P.O.A.D.P. OF
T. & D. MORAVITS SUBDIVISION

INFORMATION SHEET FOR
PRELIMINARY OVERALL AREA DEVELOPMENT PLAN
(P.O.A.D.P.)

FILE NO. 85-23-54-40
(To be assigned by the Planning Dept.)

Re: T & D Moravitz Preliminary Plan
 P.O.A.D.P.
File #: 85-23-54-40

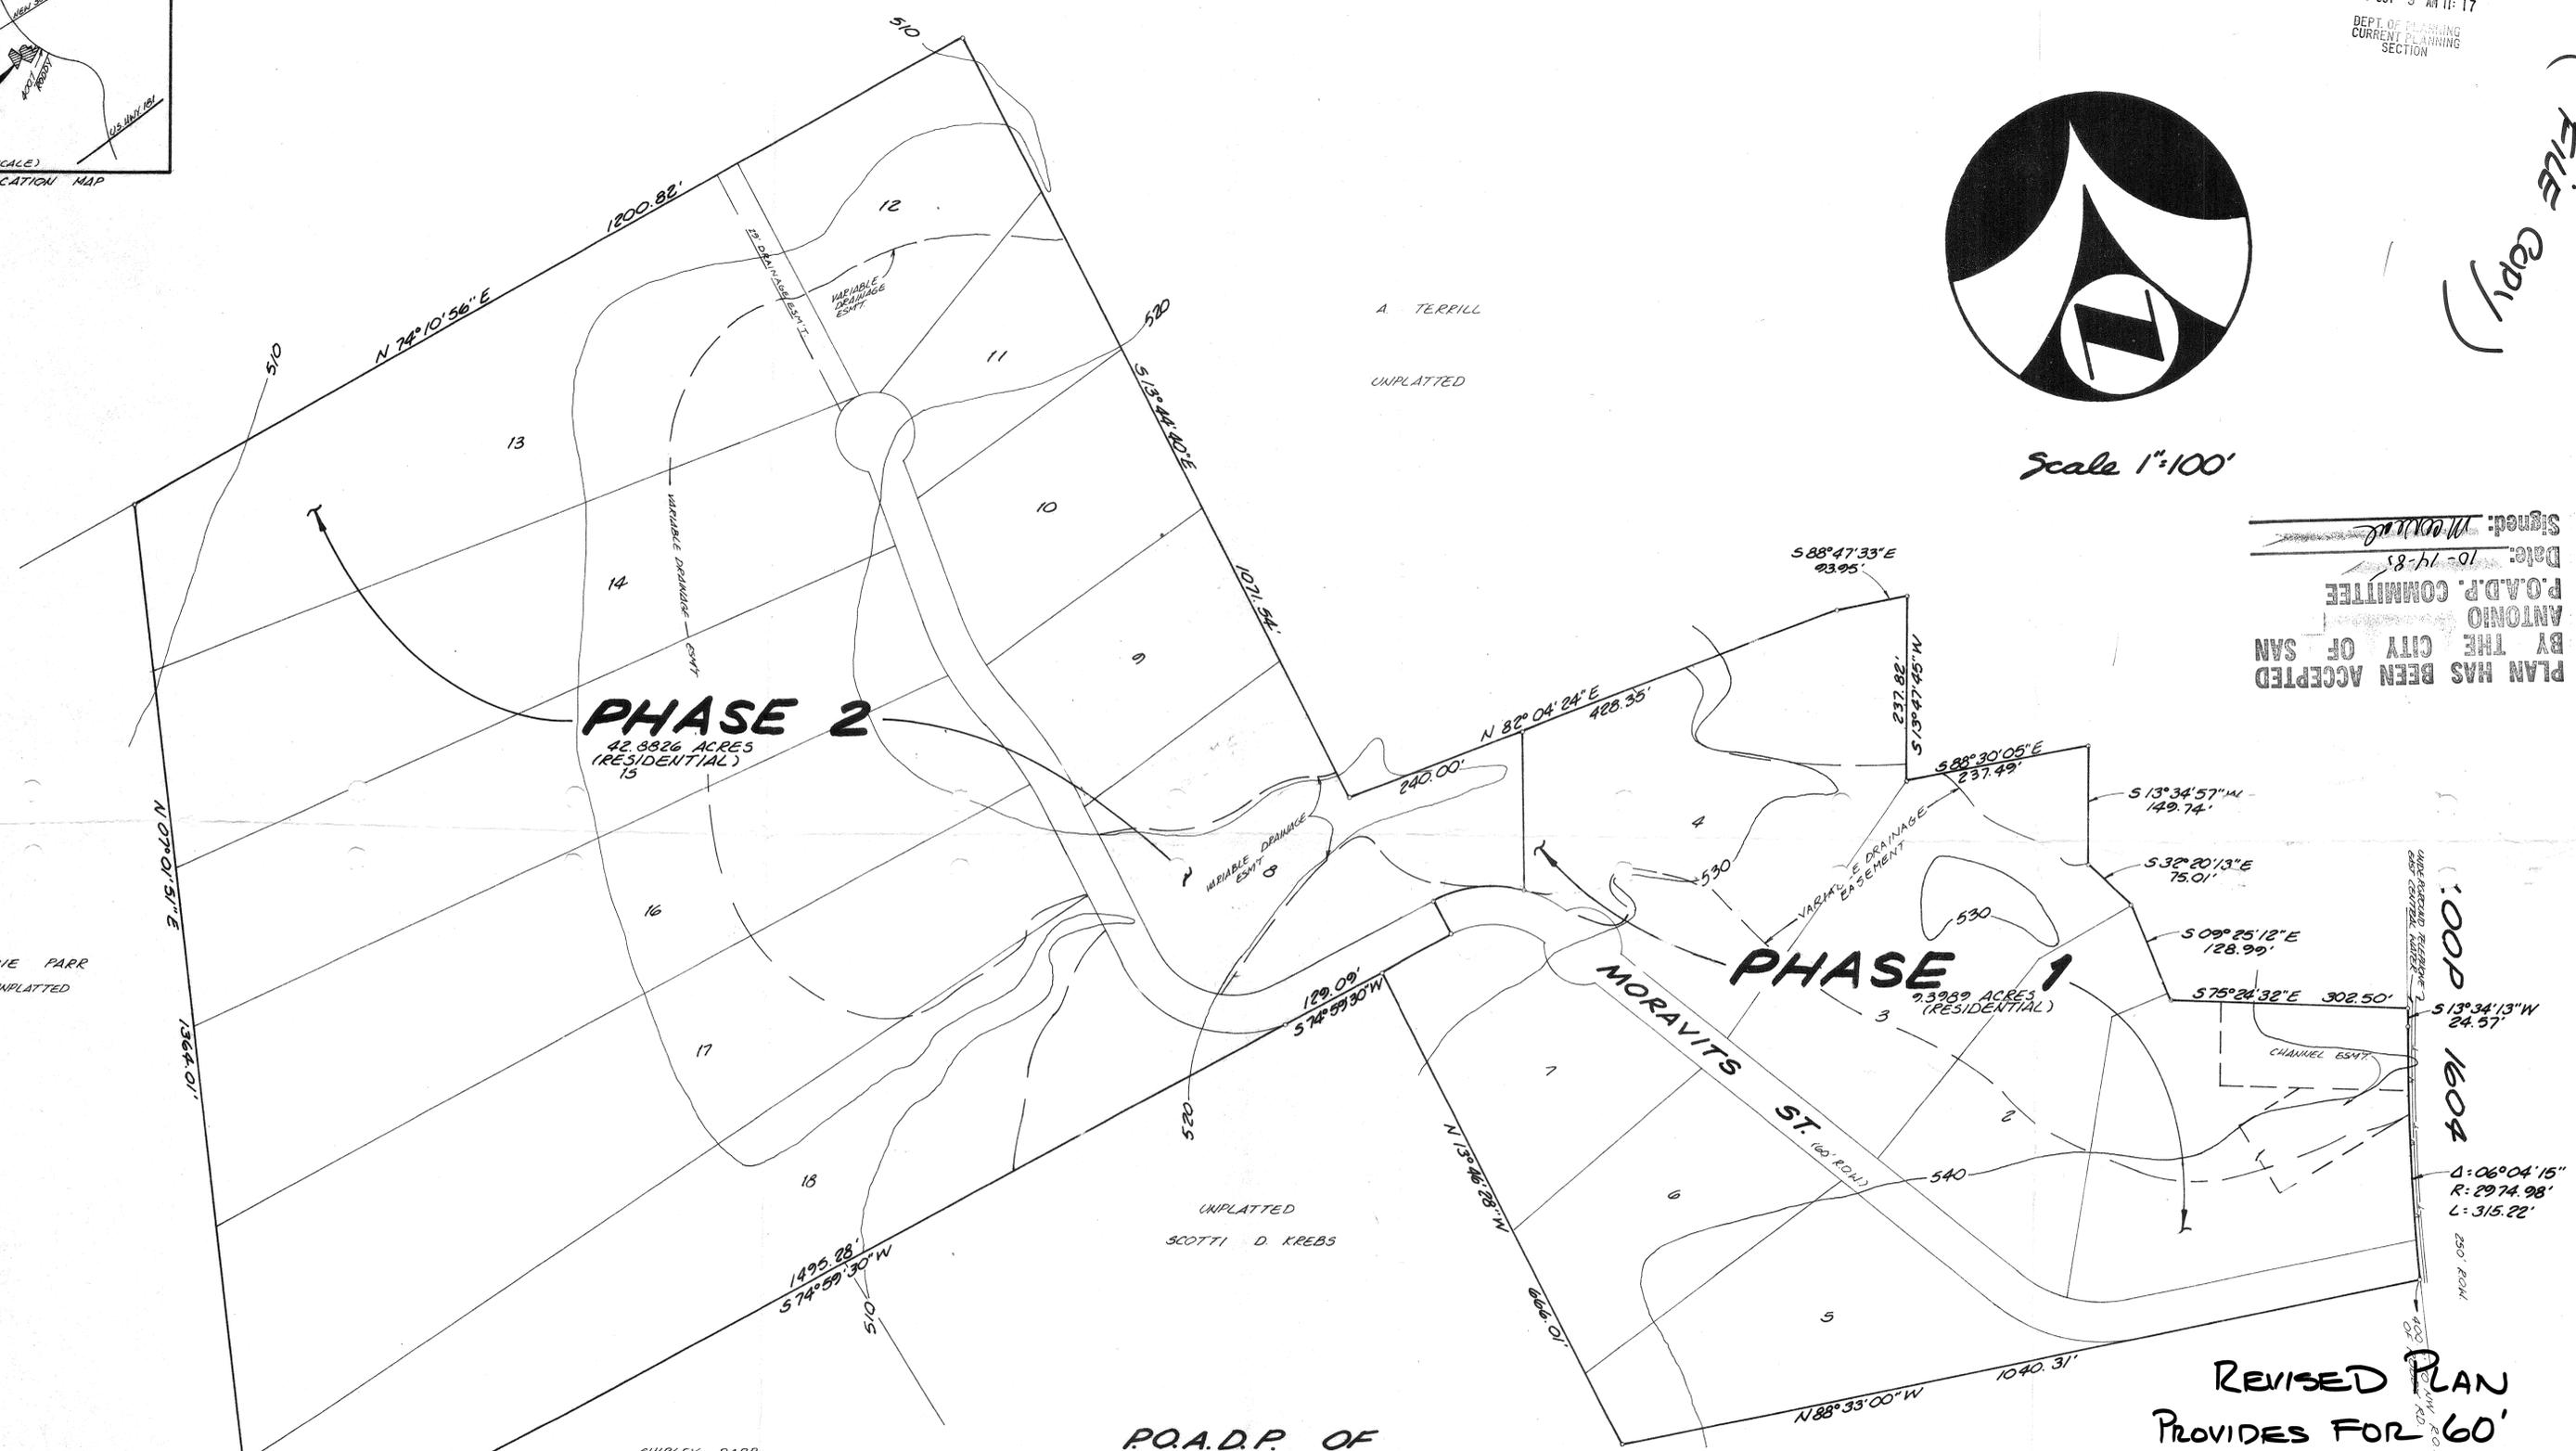
COMMENTS: Committee reviewed plan 1-11-85. Cul de sac length
was addressed and it was recommended that
an additional turnaround be provided

- () is in general compliance with the Subdivision Regulations
- (X) lacks compliance with the Subdivision Regulations regarding:
 - () Street layout
 - () Relation to adjoining street system
 - () Stub streets
 - () Street jogs or intersections
 - () Dead-end streets
 - (X) Cul-de-sac streets in excess of 500'
 - () Low density lots fronting onto major thoroughfares
 - () 24' alley(s)
 - () _____
 - () _____
 - () _____

With regard to the 2550 foot cul de sac length it is recommended that an additional turn around be provided. The preferred location is between the street terminus and FM 1604.

REVISED PLAN
PROVIDES FOR 60'
R.O.W.'s WITH CO. RD.
STANDARDS

(x) Comments: The P.O.A.D.P. Committee has reviewed and accepted your latest P.O.A.D.P. revision. You may now submit your subdivision plats for processing.
